CAPRICORN MUNICIPAL DEVELOPMENT GUIDELINES

MEETING MINUTES, POST AMALGAMATION MEETING 12

Date and Time: Thurs 25th October 2018
10:00am – 3:30pm

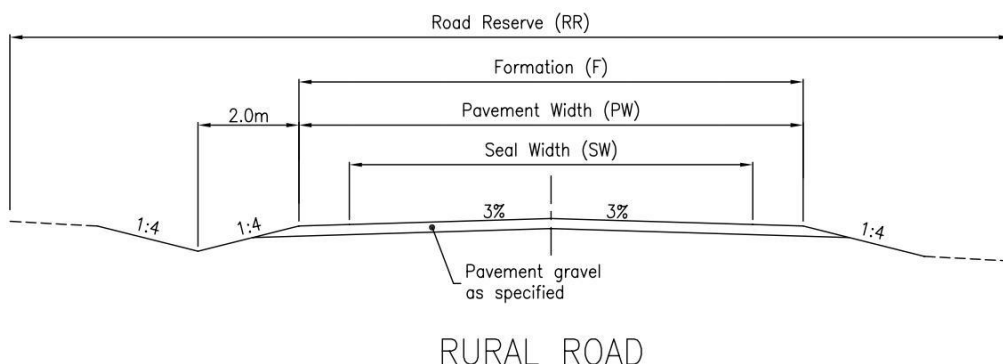
D01.14.01 Check grade of gravel – Grant;

Check consistency with standard drawings
Desirably, roads should be crowned in the centre. Typical pavement crossfall on straight roads are:

- Bituminous seal coat 3 percent*
- Asphaltic concrete pavement 3 percent*
- Cement concrete pavement 3 percent*
- Paved surfaces 3 percent*
- Gravel 5 percent*
